# Florida Department of Transportation

ROADWAY DESIGN BULLETIN 12-13 DCE MEMORANDUM 22-12 (FHWA Approved: 7/13/12) This Memo Has Expired

SUBJECT: PERMANENT AND TEMPORARY CRASH CUSHION SELECTION

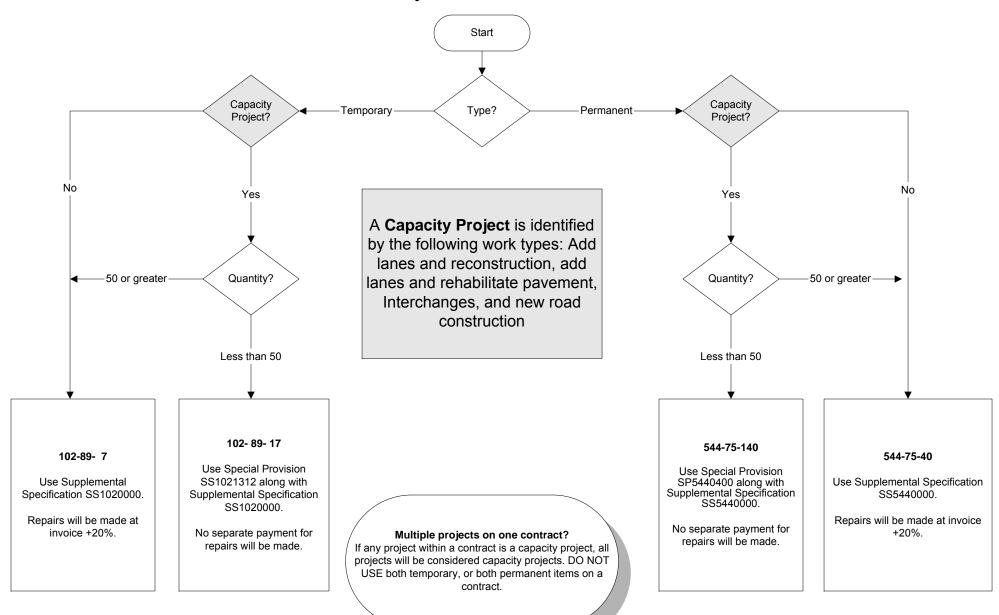
On August 15, 2012, accepted revisions to crash cushion vendor drawings will be posted on the QPL. Revisions to some crash cushion vendor drawings will consist of minor modifications requested by FDOT, while others will consist of modifications to the crash cushion lengths for speeds 60 mph and greater. For those where the lengths are modified, new QPL numbers will be issued, and limitations will be placed on the QPL for both the old and new crash cushions.

Verify the contractor is installing crash cushions using the appropriate vendor drawings. After August 15, 2012, the contractor may request to use crash cushions with the QPL limitation of "For use on jobs let on or after January 1, 2013" by submitting a Cost Savings Initiative Proposal that includes the demonstration that the length of need has been evaluated and is satisfied.
